North Carolina Building Code Council

December 18, 2018

RE: Agenda for the Monday, January, 28, 2019 NC Building Code Council Meeting (Due to December 11, 2018 snow cancellation)

**FIGURE AM109.1(1)
NO LATERAL BRACING**

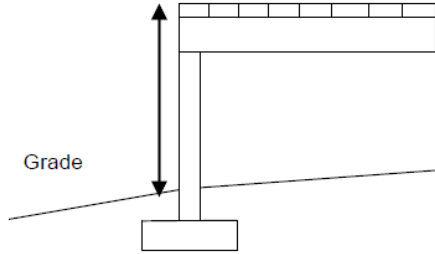
When the deck floor height is less than 4 feet (1219 mm) above finished grade as shown in Figure AM109.1(1) and the deck is attached to the structure in accordance with Section AM104, lateral bracing is not required. Lateral bracing is not required for freestanding decks with a deck floor height 30 inches (762 mm) or less above finished grade.

**FIGURE AM109.1(2)
KNEE BRACING**

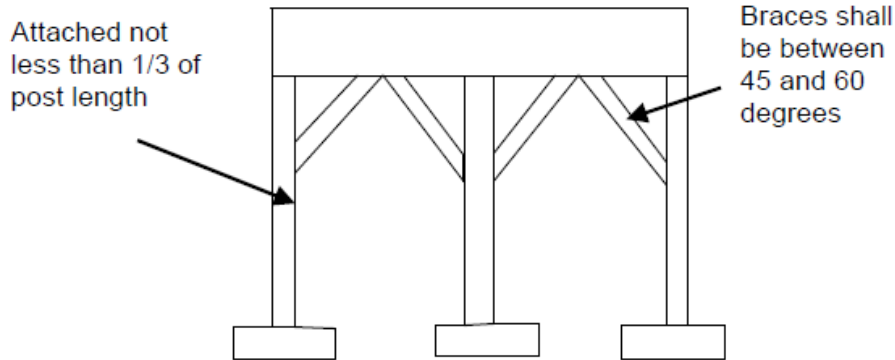
4x4 wood knee braces are permitted to be provided on each column in both directions for freestanding decks or parallel to the structure at the exterior column line for attached decks per Figure AM109.1(2). The knee

braces shall attach to each post at a point not less than 1/3 of the post length from the top of the post, and the braces shall be angled between 45 degrees (0.79 rad) and 60 degrees (1.05 rad) from the horizontal. Knee braces shall be ~~bolted~~ fastened to the post and the girder/double band in accordance with one 5/8 inch (16 mm) hot dip galvanized bolt with nut and washer at both ends of the brace of the methods shown in Table AM109.1; as shown in Figure AM109.1(2).
